TECHNICAL RESPONSE TO HCC HIGHWAYS COMMENTS

Ridge and Partners have been commissioned to respond to the Road Safety Audit undertaken by Fenley (March 2026) as part of the S278 Technical Approval Process.

Road Safety Audit Report

Proposed Continuation of Coldharbour Farm Road Emsworth

HAMPSHIRE FIRE APPLIANCE - TRACKING
(Scale at A1 1:200)

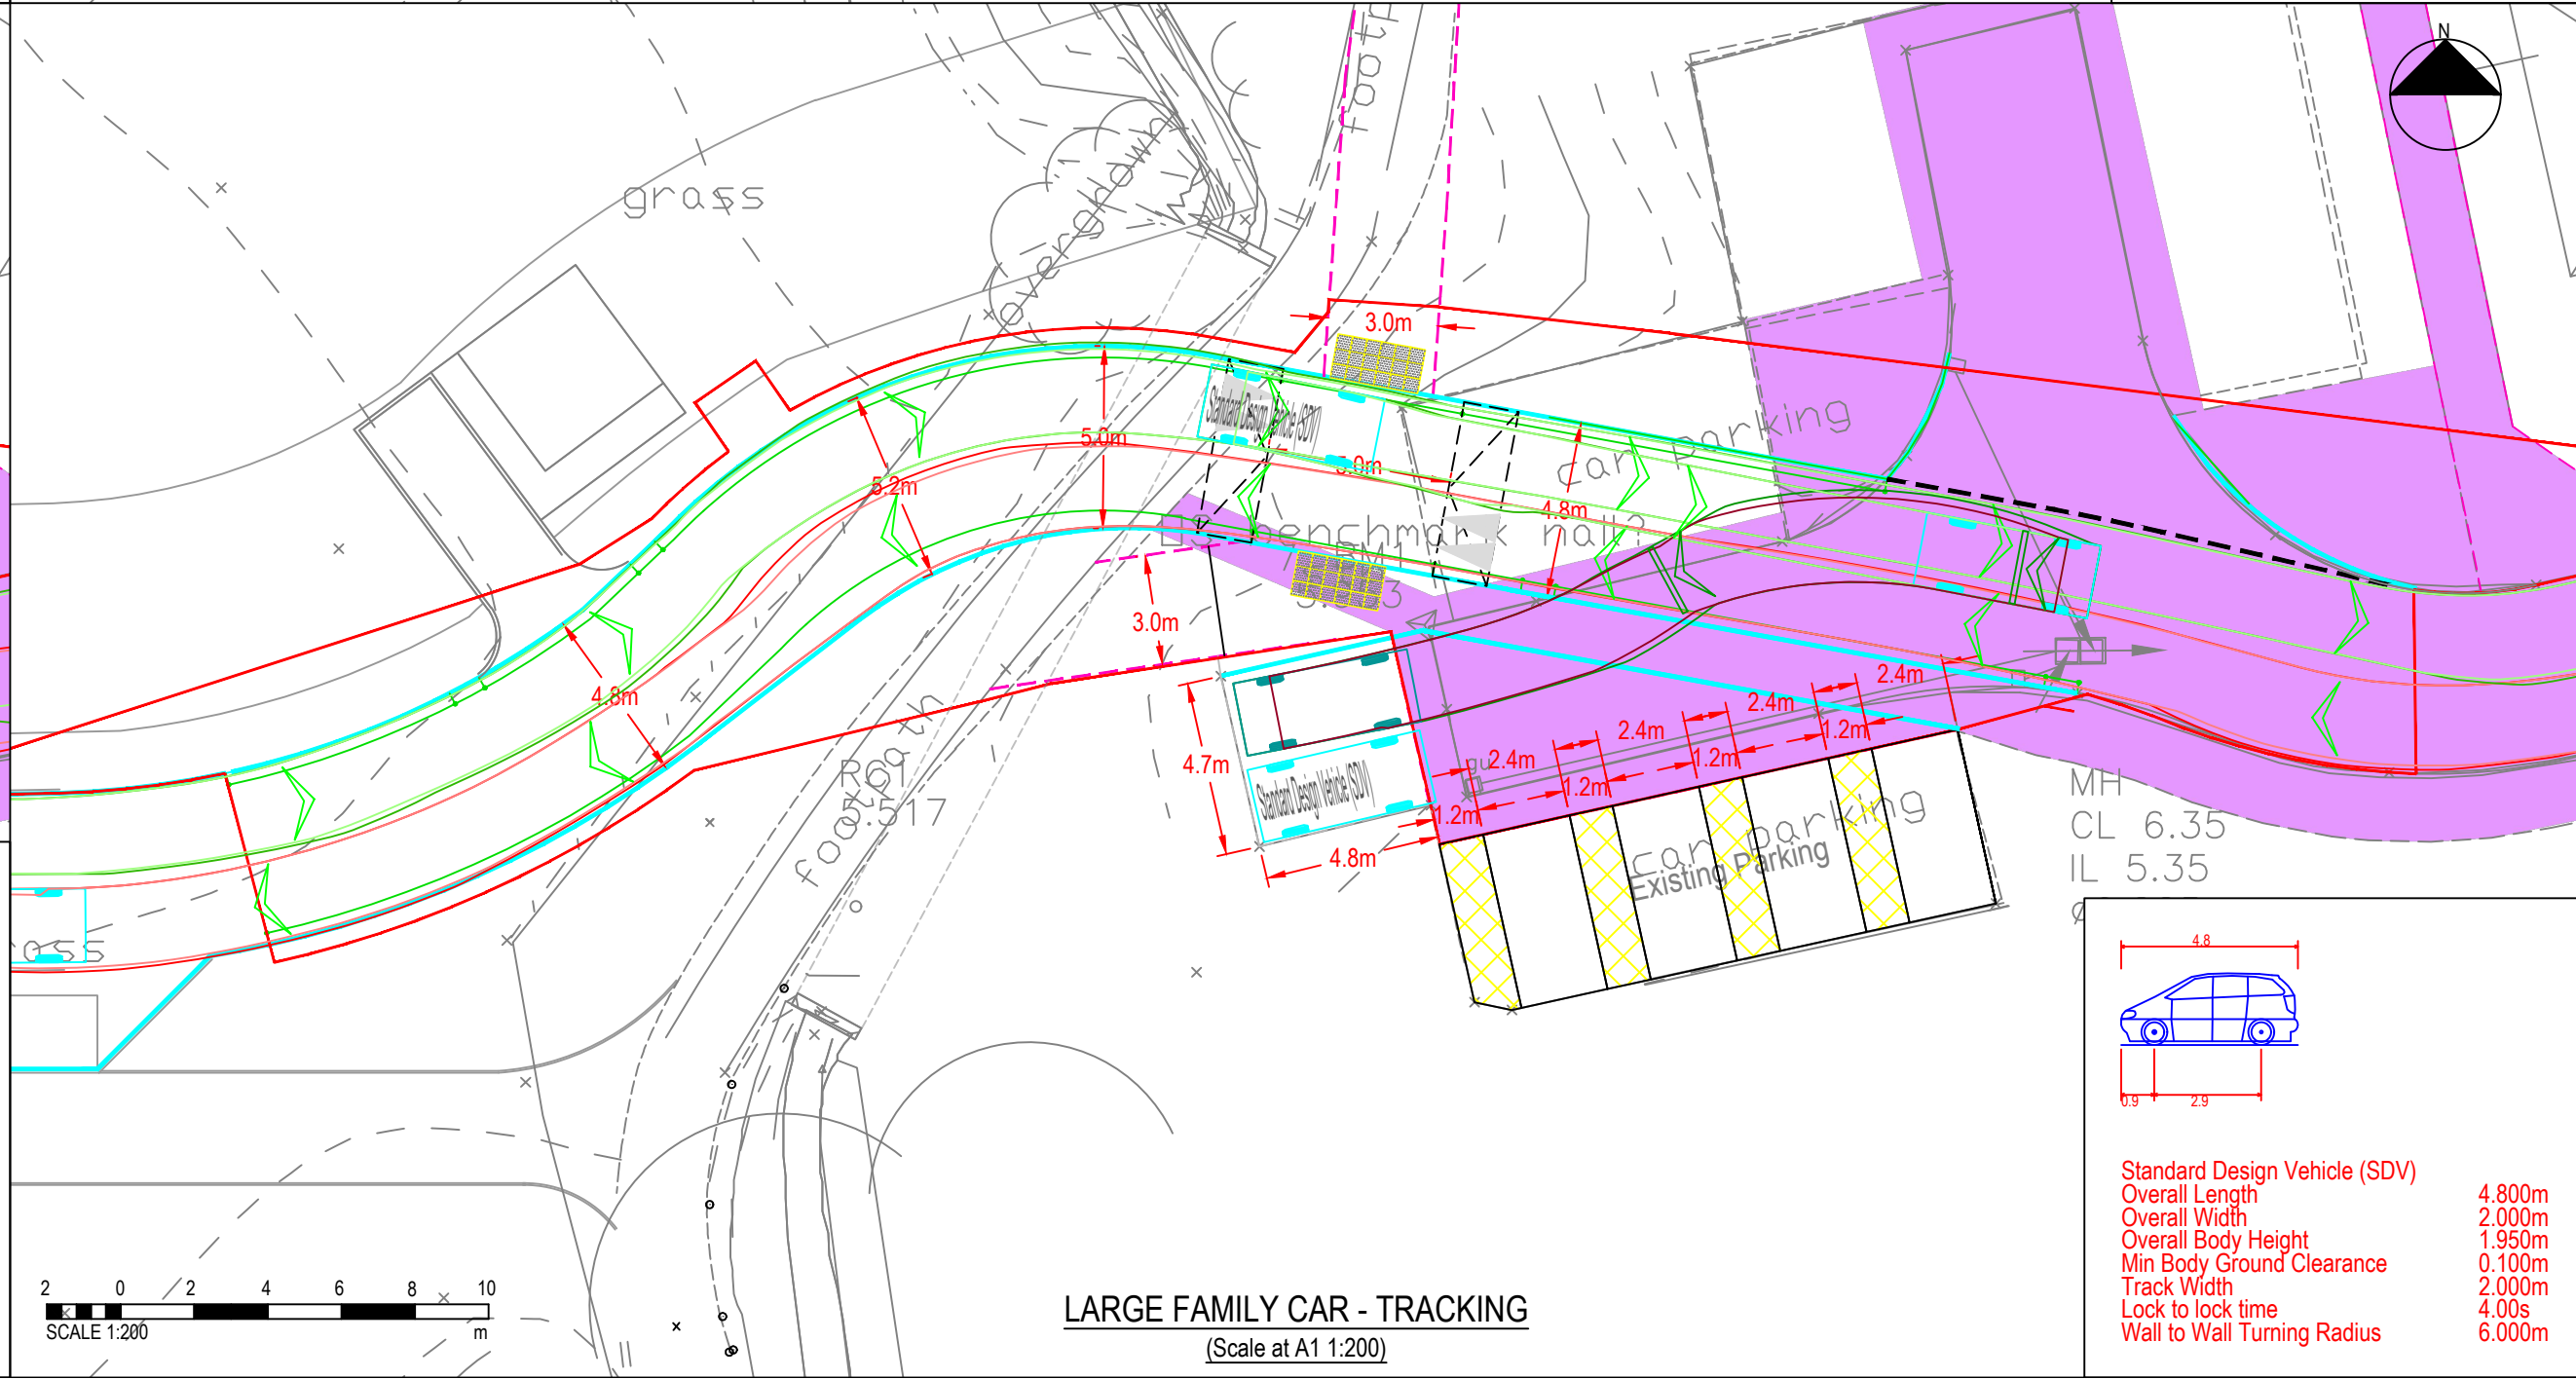
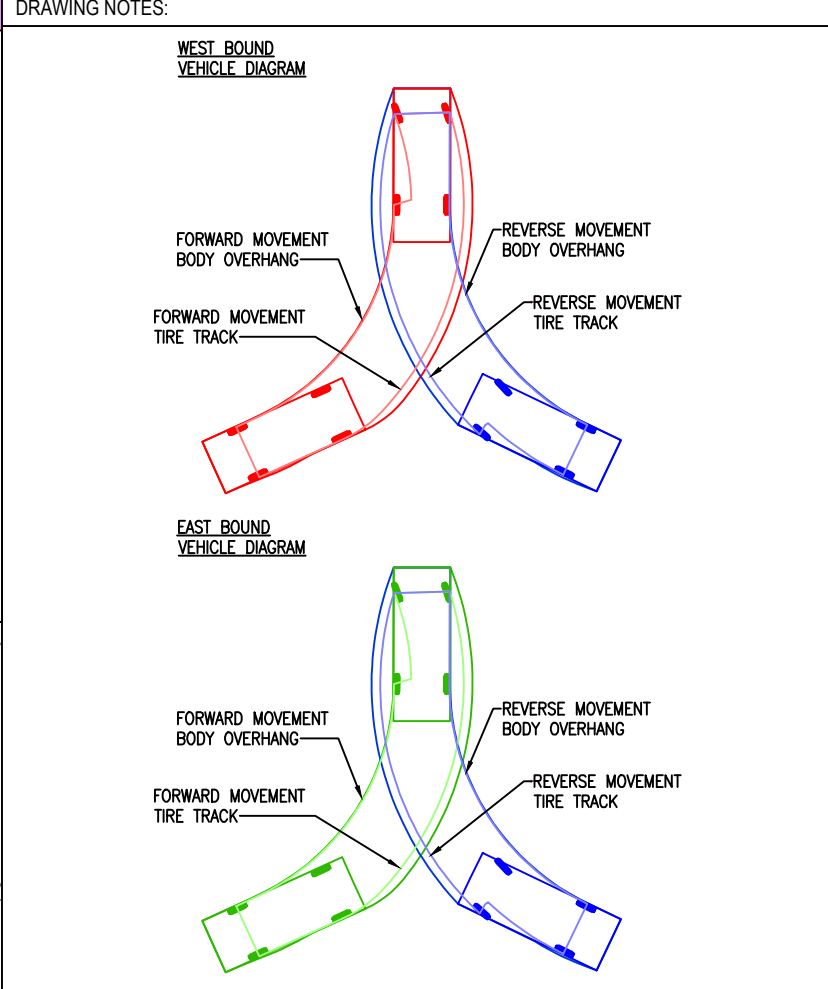
B.1.1 – Alignment may not be adequate for two-way car / LGV movements. It is recommended that the carriageway is adequate for cars and LGVs to pass one another.

We have provided updated tracking Drawing 23339-JUBB-XX-XX-DR-X-001200 REV C4 that shows in the bottom right that cars can pass each other.
